CHANGE ORDER REQUEST

PROJECT: Hwy 30 Mount Vernon (10th Ave to Virgil Ave)
STP-A-030-7(159) - - 86-57
Linn County, Iowa
Bid Order 106, Letting Date: April 16, 2013

RE: **STREB CHANGE ORDER #27**
Add Light Pole - west end of 10th Ave Roundabout
Per Revised P.02 Drawing
KWS Inc

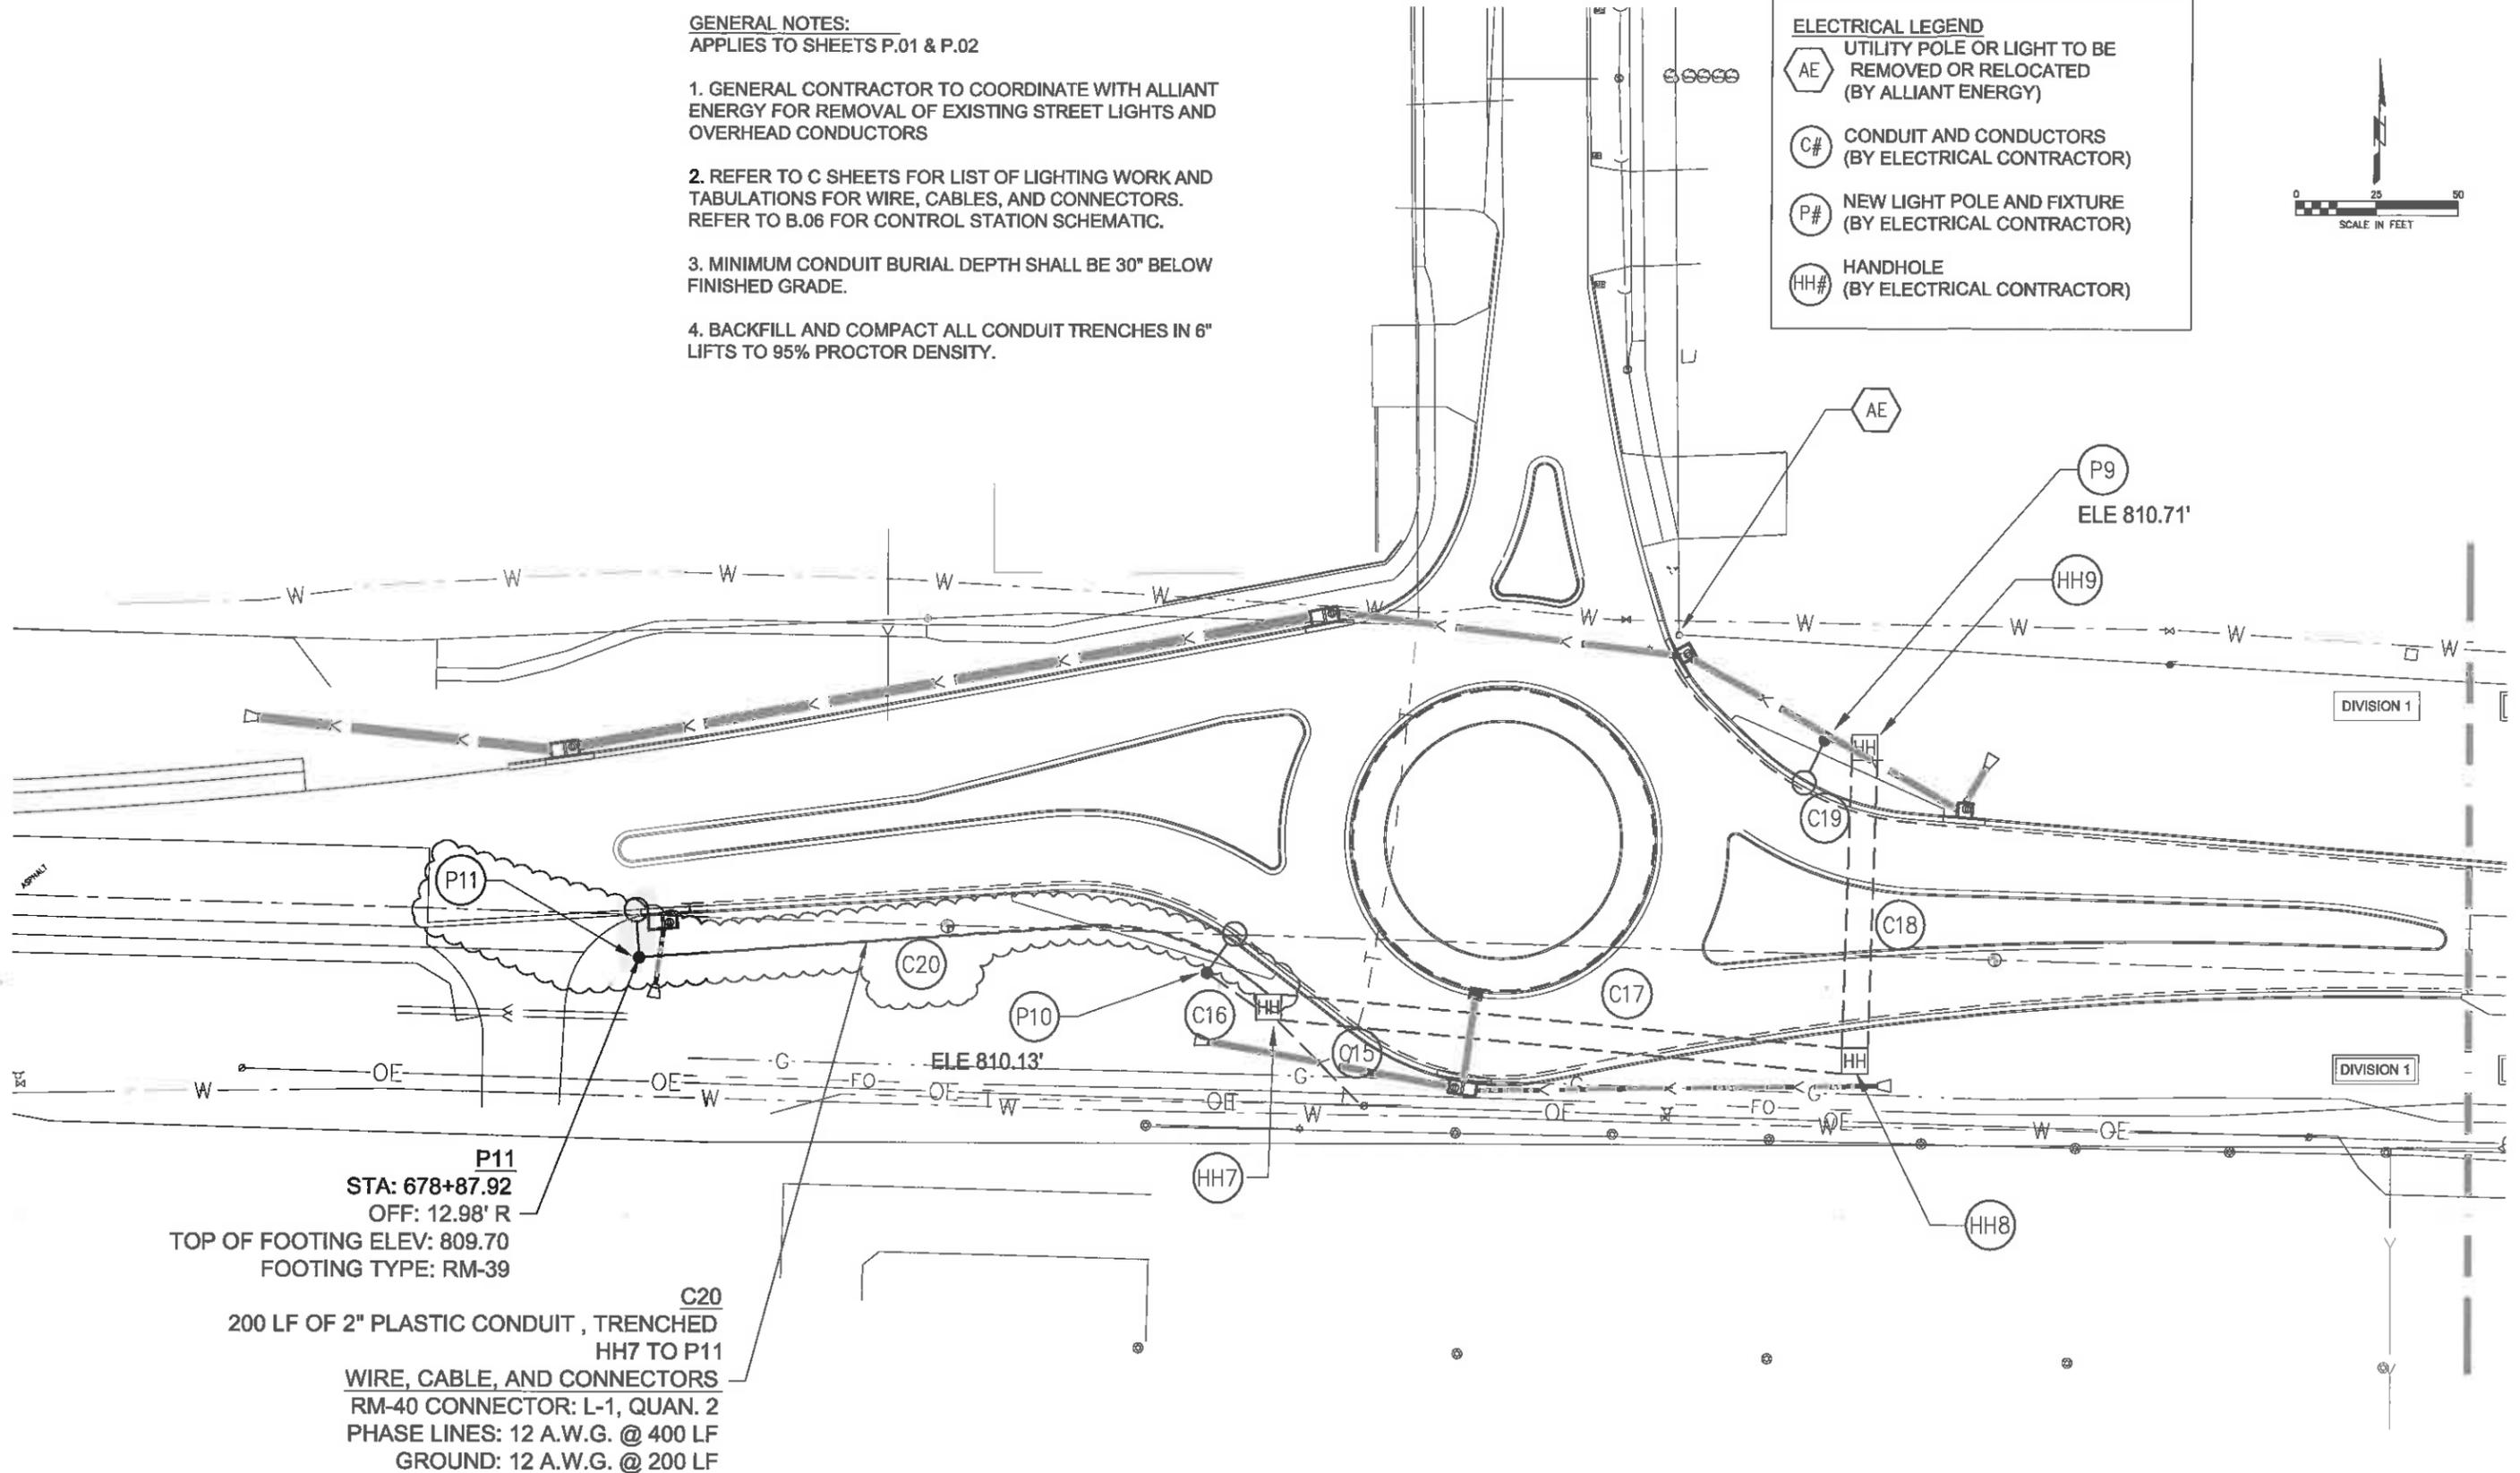
Steve,
Here is the revised P sheet with the location and information about the light pole that is to be added at the west end of the 10th ave roundabout. It will have a 4' longer arm than the other light poles installed on this project. Everything else should be the same items we used before. Would you be able to install this light pole and wiring at the bid unit price to avoid a CO and speed up the process?
Let us know if you have questions.
Thanks,

P11
STA: 678+87.92
OFF: 12.98' R
TOP OF FOOTING ELEV: 809.70
FOOTING TYPE: RM-39

C20
200 LF OF 2" PLASTIC CONDUIT, TRENCHED
HH7 TO P11
WIRE, CABLE, AND CONNECTORS
RM-40 CONNECTOR: L-1, QUAN. 2
PHASE LINES: 12 A.W.G. @ 400 LF
GROUND: 12 A.W.G. @ 200 LF
